MEMORANDUM FOR: Margaret Federline, OCM/KC
FROM: *Ray Fraley*
R. F. Fraley, ACNW
SUBJECT: EPA STANDARDS FOR THE HIGH-LEVEL WASTE REPOSITORY

COMMENTS ON STRINGENCY OF EPA HLW REPOSITORY STANDARDS

COMPARISONS OF LIMITS ON DOSES TO THE POPULATION FROM VARIOUS RADIATION SOURCES

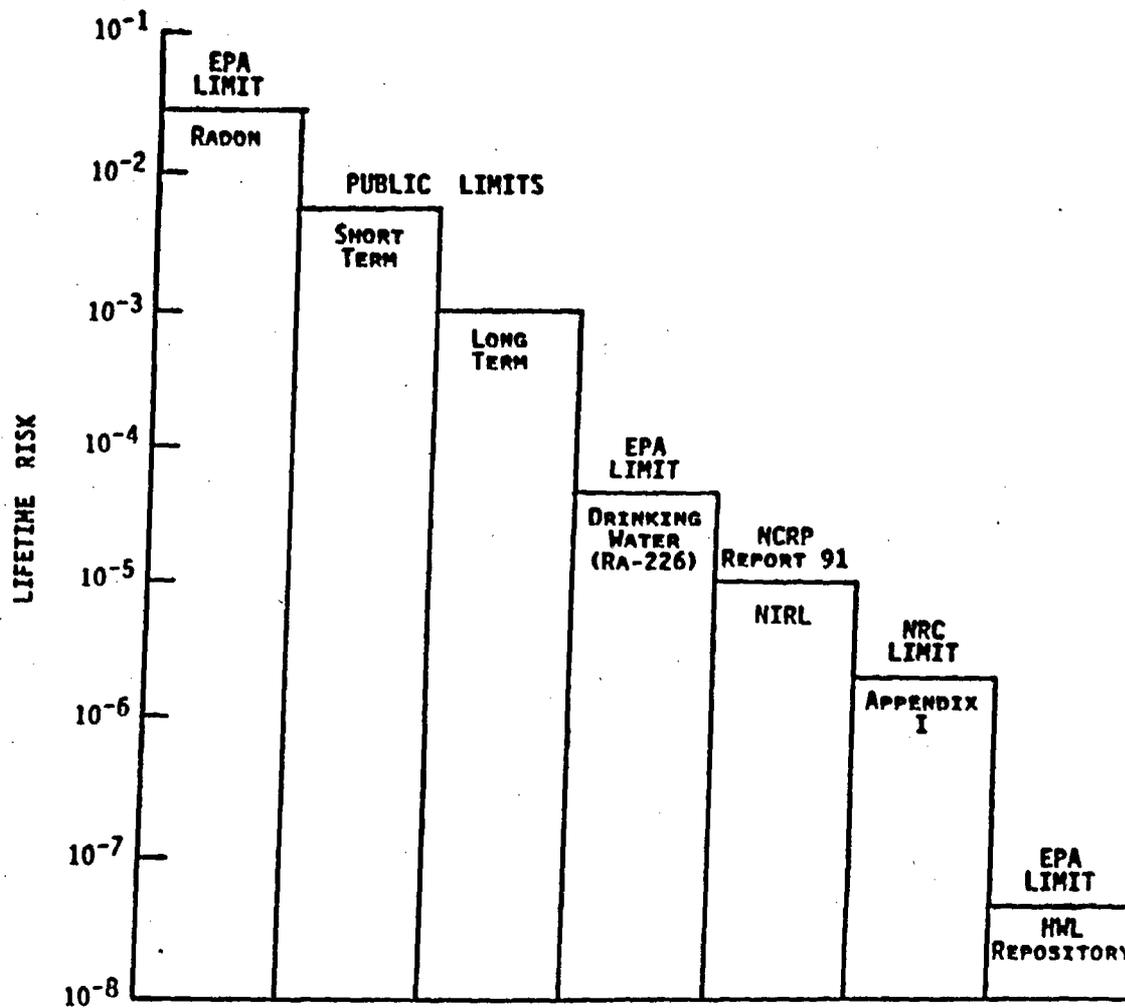
Comparisons of the EPA HLW Standards to other regulatory limits, such as the NRC Appendix I regulations and the EPA Drinking Water Standards, reveals that the HLW Standards are stringent. In fact, according to Dr. Kocher, the EPA HLW Standards are the lowest of any radiation standards being applied to the U.S. population today [see accompanying figure].
